## M E M O R A N D U M

**RE:** Town of Webb TOBIE Phase II Bridge Variance  
P2012-21

The proposed bridge (Exhibit 16B) rendering is shown below:

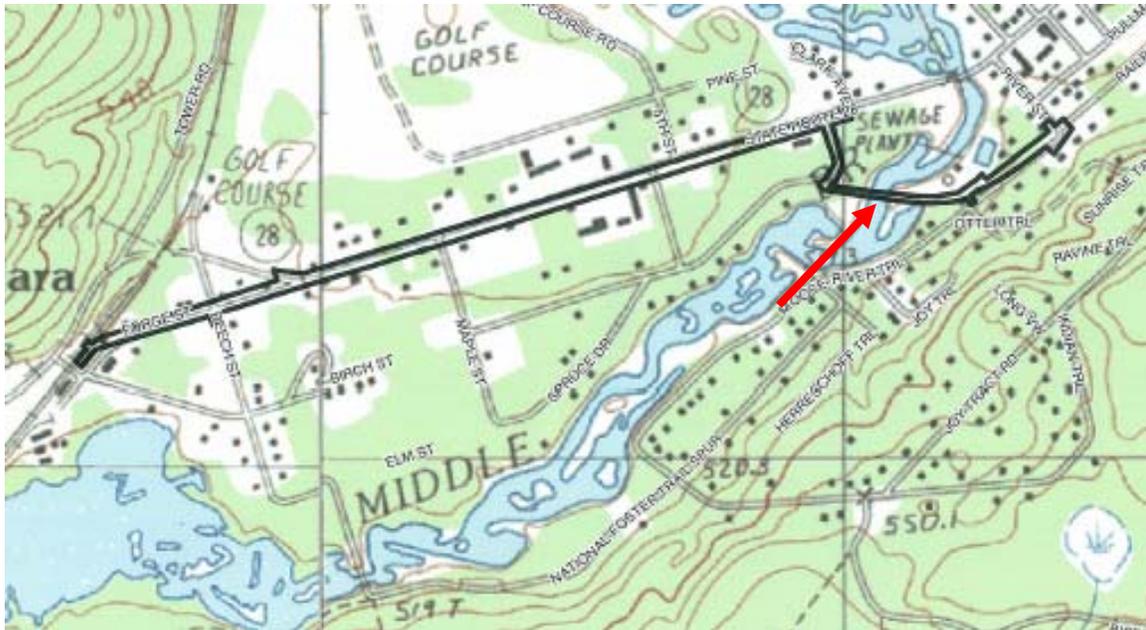
Tim Quinn stated that he felt the color of the natural wood railings on the bridge does not appear to blend in and that wire mesh would be better. He expressed concern about the removal of vegetation and questioned whether vegetation would be replaced so that his residence would continue to be screened from other locations along the River that emit light pollution. He stated that the size of the gate for the proposed bollard and gate system seemed to be too large. He expressed concerns about the railing along the trail hampering a deer crossing.
